IN no.: **IN-141 rev 1.0**

Device affected: **nRF52840-QIAA and nRF52840-CKAA**

Description of change:

The nRF52840 revision 3 (build code Fx0) introduces four changes to the product.

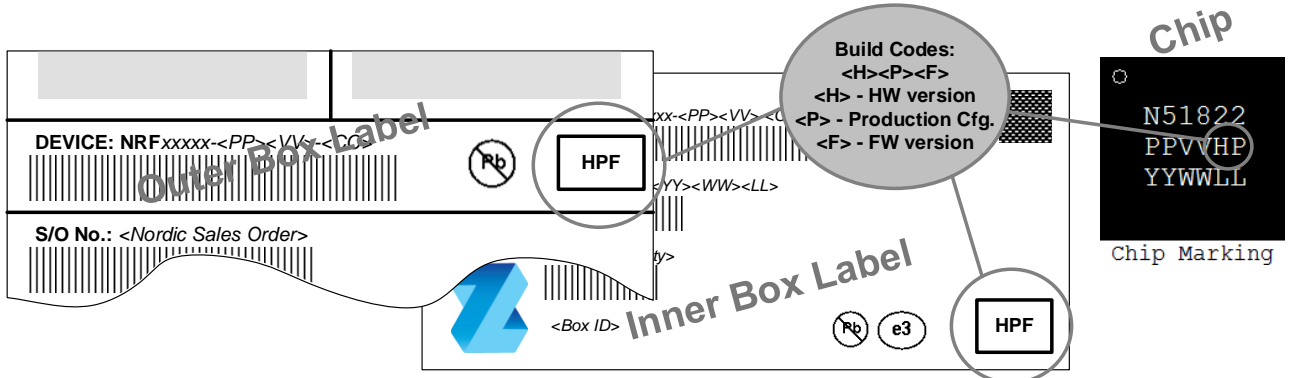
Changes to pin-out:

Existing PCB designs for the nRF52840 (rev. 2 and earlier) are compatible with the nRF52840 revision 3 without performance degradation. For new designs an updated bill of material for the reference schematic is available in the product specification rev. 1.5 or later. The new bill of material requires one less decoupling capacitor.

Chips:

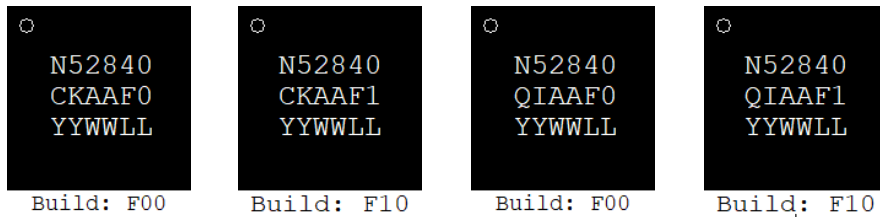
Marking/Shipping labels:
